(CBM Caledon Quarry) CAART COMMENT SUMMARY TABLE RESPONSE #1 – [BLASTING]

Please accept the following as feedback from the Caledon Aggregate Review Team (CAART). Fully addressing each comment will expedite the potential for resolution of the consolidated CAART comments and individual agency objections. **Additional comments may be provided once a response has been prepared to the comments raised below and additional information provided.**

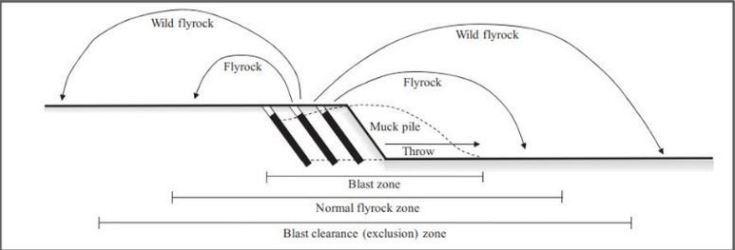
19.	Three distances are noted for different bench heights indicating the estimated standoff distances to adjacent receptor residences based on estimated air overpressure levels. These calculations	Blast Impact Assessment: Page 27	Acknowledged. As a note below Table 3 and Table 4: 3) Recorded levels will be dependant on the weather conditions. Following the bullets:	Resolved subject to the additional information being added to the report	The Addendum (“Addendum to the Blast Impact Assessment Report May 27,2026) attached, provides the noted additional information.

Blasthole Diameter (mm)	Burden (m)	Stemming (m)	Maximum Throw (m) ¹⁾		Minimum Separation ^{2) 3)} (m)	Face Burst	Cratering	102	3.3 ⁴⁾	2.1 ⁵⁾	36	115	230	102	3.3 ⁴⁾	2.5	36	73	146	102	3.3 ⁴⁾	3.0	36	46	92	102	3.3 ⁴⁾	3.5	36	31	62	Resolved subject to the additional information being added to the report	The Addendum ("Addendum to the Blast Impact Assessment Report May 27, 2026) attached, provides the noted additional information.
Blasthole Diameter (mm)	Burden (m)	Stemming (m)	Maximum Throw (m) ¹⁾				Minimum Separation ^{2) 3)} (m)																														
			Face Burst	Cratering																																	
102	3.3 ⁴⁾	2.1 ⁵⁾	36	115	230																																
102	3.3 ⁴⁾	2.5	36	73	146																																
102	3.3 ⁴⁾	3.0	36	46	92																																
102	3.3 ⁴⁾	3.5	36	31	62
